**Austino PC Hobsonville Grove: CI 23 response September 2024 – Updated November 2024 (highlighted)**

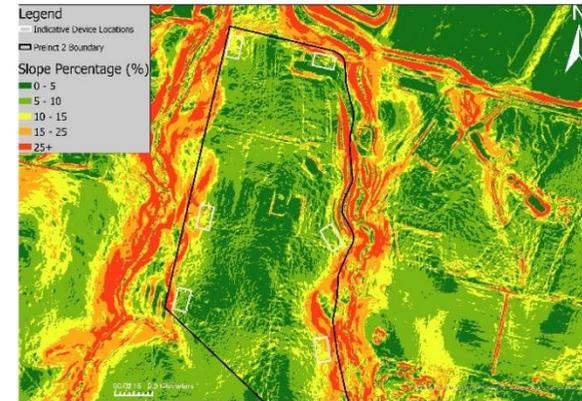
Figure 6 of the SMP shows site slope gradients. Figure 32 of the SMP shows indicative stormwater device locations and sizes. Some of the devices are located in quite steep areas (25+% slope gradient). How will this affect the feasibility of using bioretention devices? if bioretention devices are not feasible because of the gradient what other options can be used, please clarify and provide guidance in the SMP

topography. The updated device locations are shown in Figure 32 of the SMP.

The effective water depth of the bioretention devices has been changed to 0.7 m. This accounts for the maximum ponding depth and recommended void space for the media outlined in GD01.

The image below shows the updated indicative location of the Precinct 2 devices overlaid with the existing site's slope. The slope analysis was conducted with 2016 LiDAR data. It should be noted that there is dense vegetation surrounding the Trig and Rawiri stream which can misrepresent the area's topography. The image below illustrates that there are feasible bioretention device locations in Precinct 2. In the absence of earthwork plans the device locations are indicative only. The devices in Precinct 1 are proposed to be private and are not shown device plan.

Upper Harbour Greenways Plan (2019) and connections in the area identified in that Plan

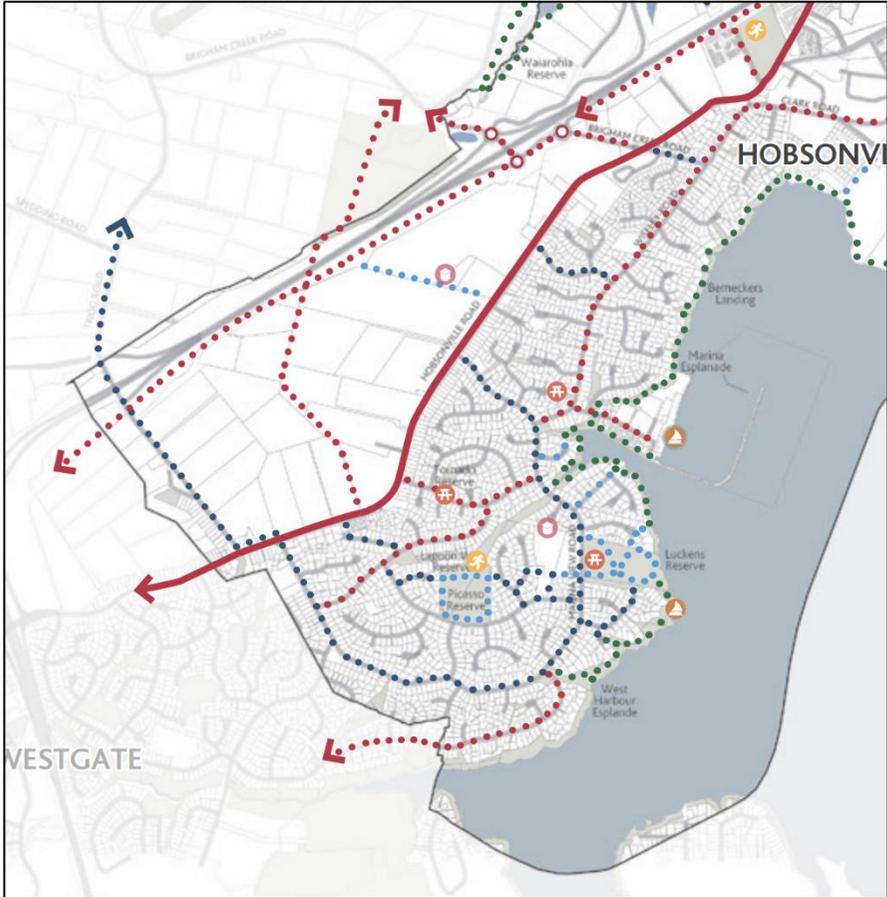
- The response refers to Fig. 20 as the 'Conceptual Masterplan' - should this be the 'Opportunities Plan' or refer to Figure 23 (which is the 'Conceptual Masterplan')?
- The response also includes a couple of typos referring to 'Harbourside Grove Precinct Plan' rather than 'Hobsonville Grove Precinct Plan', which could create confusion.
- In addition, it would be helpful to include a plan that differentiates between existing and proposed/desirable active mode linkages in the surrounding environment/network

Please note that the Opportunities Plan Figure 20 of the Urban Design Statement has been updated to include existing and proposed cycle trails within the wider surrounds (refer to updated **Appendix 4**).

The Upper Harbour Greenways Plan 2019 is a visionary and guiding document commissioned by Upper Harbour Local Board in 2019, which identifies potential walking and cycling links for daily / commuter trips and recreation trips. It is considered that the Upper Harbour Greenways Plan 2019 has limited applicability to for the PPC request area. As shown in Figure 1, the key routes and connections for Hobsonville and West Harbour does not appear to consider the Whenuapai Structure Plan, proposed Supporting Growth Alliance arterial routes (such as Spedding Road), or follow the Rawiri Stream corridor. The solid red line along Hobsonville Road denotes an existing express network, while the dotted red lines denote a proposed / aspirational express network. The dotted blue line along Trig Road (passing the primary school) denotes a "proposed / aspirational Local Network – Street." Furthermore, these trails appear to be for daily commute purposes, rather than for recreational purposes, where their alignment has been locked-in to follow natural features, public facilities, or other points of interest. There is accordingly a degree of flexibility to achieve indicative connections over greenfield land to achieve a purpose, particularly if they do not follow the alignment of a collector or arterial route. The proposed / aspirational trails largely fall outside of the PPC area and have been somewhat superseded by construction of existing cycle and pedestrian pathways on Westpoint Drive and proposed pathways within the Spedding Road corridor. However, it is noted that pathways that would be formed alongside the indicative roads shown in the precinct plan could connect pathways on Westpoint Drive with the potential / aspirational pathway alongside the Trig Stream (as indicated in the Upper Harbour Greenways Plan (see Figure 1)). In this way, the Hobsonville Grove Precinct Plan will contribute to the network of pathways for daily commute purposes. Over time, the Hobsonville Grove Precinct Plan will connect future residential areas with employment, retail amenities, public transport services, and a school.

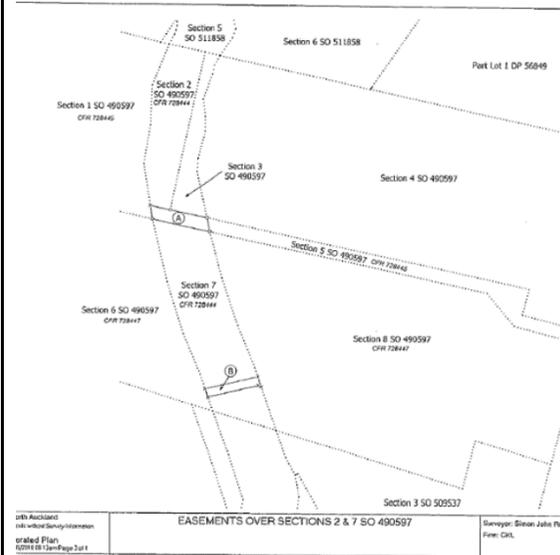
I2	<p>Please confirm whether the proposed road connections, as indicated in Precinct Plan 2 (Hobsonville Grove Precinct),</p>	<p>To better understand whether the proposed infrastructure, which will be necessary to provide access into the PCA, is feasible from a geotechnical perspective</p>	<p>Fulfilled</p> <p>The attached memo prepared by Fahad Khan (CMW Project Geotechnical Engineer) responds to the Matters in I2 (<b>Attachment E</b>).</p>

<p>are feasible from a geotechnical perspective:</p> <p>a) Indicative connection point to Westpoint Drive, at the location indicated on the precinct plan; and</p> <p>b) Indicative collector road connection to 23/25 Trig Road, at the location indicated on the precinct plan</p>		<p>The feasibility of constructing the roads indicated in the precinct plan will be confirmed at resource consent / detailed design stage. There are no identified geotechnical hazards or other fatal flaws to the construction of roads in the location indicated</p>
<p>I3</p>	<p>There are several existing features and infrastructure networks in the indicative location of the Westpoint Drive Connection Point, including:</p> <ul style="list-style-type: none"> <li>• stormwater manholes and outlets</li> <li>• overland flowpaths</li> <li>• vehicle crossings for 92D Hobsonville Road and 70 &amp; 72 Westpoint Drive; and</li> <li>• stream restoration project works (pathway &amp; rest area) and the existing retaining wall.</li> </ul> <p>These features may suggest that a crossing slightly south of the indicated location may be preferable. Please confirm whether:</p> <p>a) any alternative locations for the connection point have been considered; and</p> <p>b) there is sufficient scope within the PPC to allow for an alternative location for the connection point</p>	<p>To better understand how the PPC has considered alternative options for the construction of the proposed Westpoint Drive connection</p> <p><b>Comment:</b> Item I3, not satisfied – Under subsection a) we requested confirmation of whether alternative road connection points had been considered. The response to I3 focusses on subsection b), but there appears to be no consideration of subsection a).</p> <p>While there is provision within the scope of ‘general accordance’ within Standard I1.6.1.2 and/or the Restricted Discretionary pathway to more the Westpoint Connection, it appears that the location shown on Precinct Plan 2 would already be unsuitable, or not ideal such that an alternative location and consideration of the above provisions would be automatically necessary. In addition, moving the indicative connection to a more likely location, such as opposite 70 Westpoint Drive (undeveloped site) then provides clearer indication to</p>	<p>The crossing location is indicative and subject to detailed design. The road connections can be located and designed to either avoid or mitigate effects on the infrastructure, vehicle crossings, and overland flow paths. We maintain that the existing and proposed AUP(OP) provisions (such as the earthworks and subdivision controls), are adequate to avoid and mitigate such effects. Furthermore, it is unlikely that Council / Auckland Transport would accept the vesting of a public road where the risk of land instability has not been adequately avoided, remedied, or mitigated.</p> <p>Subdivision and development within the Hobsonville Grove Precinct that does not provide road connections in the location shown in the precinct plan would require resource consent for a restricted discretionary activity under proposed rule I1.4.1(A2). Where a road is not provided where indicated on the precinct plan, the proposed matters for discretion would provide an opportunity for Council to consider an alternative road alignment where it provides an appropriate connection / integration with adjacent landholdings.</p> <p>For this reason, it is considered that the exact location of the indicative roads shown in the precinct plan do not need to be determined as part of this PPC request and can be determined at resource consent stage</p> <p>Austino currently have easement rights where the proposed future bridge is located (see easement A in image below). In addition, Austino have similar easement rights (easement B) to the south as well as an existing right of way crossing to the north at 1/100 Hobsonville Road. All of these locations have been considered for the proposed bridge as</p>

**Request:** Please respond to subpoint (a) of I3, including a simple review to ensure the indicative connection is shown in a location which is likely to be suitable for construction, and identify any alternative locations for the connection point that have been considered as part of this process. Please note that highly detailed construction drawings in an analysis of alternatives are not required

Consideration has also been given to coordination with the future Watercare trunk wastewater main which is in the location of the Spedding Road designation. We have been working with Watercare in regards to a future planned truck wastewater main, this has potential to also become part of any future bridge design.

To summarise, throughout the process undertaken to date there has been substantial high level planning and thought gone into the bridge position, as well as impact it would have on existing and proposed infrastructure.
